Staff Report and Recommendations Agenda of May 13, 2024, Item 9a

County of Ventura • Resource Management Agency

A request for a Certificate of Review for a remodel and addition to a residence located at 1468 Bardsdale Avenue, Fillmore, CA 93015 (Historic Site of Merit). The scope of work includes the remodel of 325 square feet and an addition of 168 square feet on the east side of the single-family dwelling and an addition of 9 square feet on the south side. Additionally, an existing condenser and existing water heater will be relocated as part of the remodel and addition. (Case No. CH23-0032).

Figure 3 – Proposed Additions

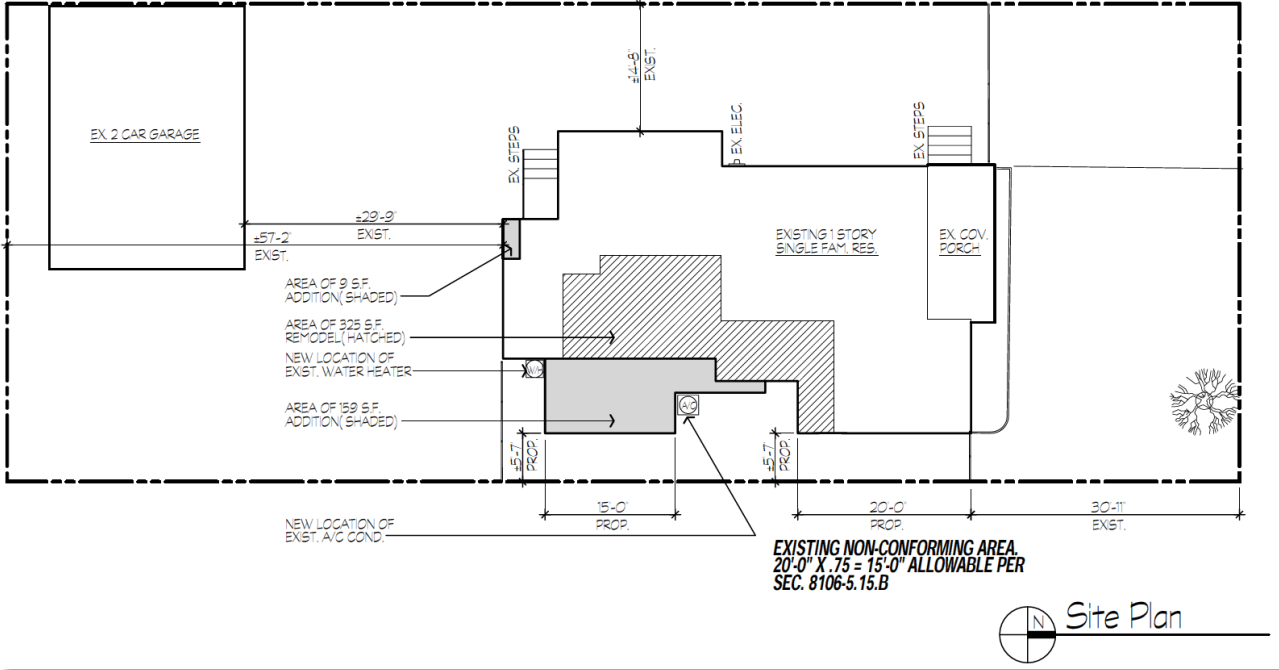
Standards	Staff Comments
<p>#9. New additions, exterior alterations, or related new construction will not destroy historic materials, features, and spatial relationships that characterize the property. The new work shall be differentiated from the old and will be compatible with the historic materials, features, size, scale and proportion, and massing to protect the integrity of the property and its environment.</p>	<p>Differentiation: The proposed design would match visual qualities of the existing residence and utilize HardiePlank® lap siding, Milgard vinyl windows, and shingle roofing. However, the essential form of the primary new addition would be separated from that of the existing residence such that it can be clearly identified as the later addition.</p> <p>CHB staff considers the proposed addition on the residence’s east side different enough so as to be recognizable as new construction. However, the rear addition of 9 square feet, while of limited visibility, is not clearly differentiated or identifiable as a later addition by visual quality or form.</p> <p>Compatibility: The height, scale, and massing of adjacent building should dictate the height, scale and massing of new construction. The proposed additions appear to be compatible with the height, scale, and massing of the residence and would be subordinate to the existing roof profile. Therefore, the proposed construction would not detract from the building’s ability to convey its significance as a contributor to the eligible district.</p> <p>Based on the above considerations, CHB staff determined the scope of work is generally consistent with this Standard.</p>

However, the applicant proposes the use of vinyl single-hung windows in the proposed new construction. Generally, original windows would consist of double-hung windows with raised wood moldings. The appearance of the new windows should be consistent with the general characteristics of a historic window of the type and period.⁸ In many cases, this may be accomplished using substitute materials.⁹

- **Recommendation #1: Windows.** The applicant should match the proposed new windows to the historic windows to the extent feasible in terms of configuration, materials, details and finish in order to be more compatible with the overall historic character of the building. The original windows would have consisted of double-hung windows with raised wood moldings.
- **Recommendation #2: Heating and Cooling Equipment.** The applicant should screen any exterior heating and cooling equipment with landscaping to reduce visual impacts.
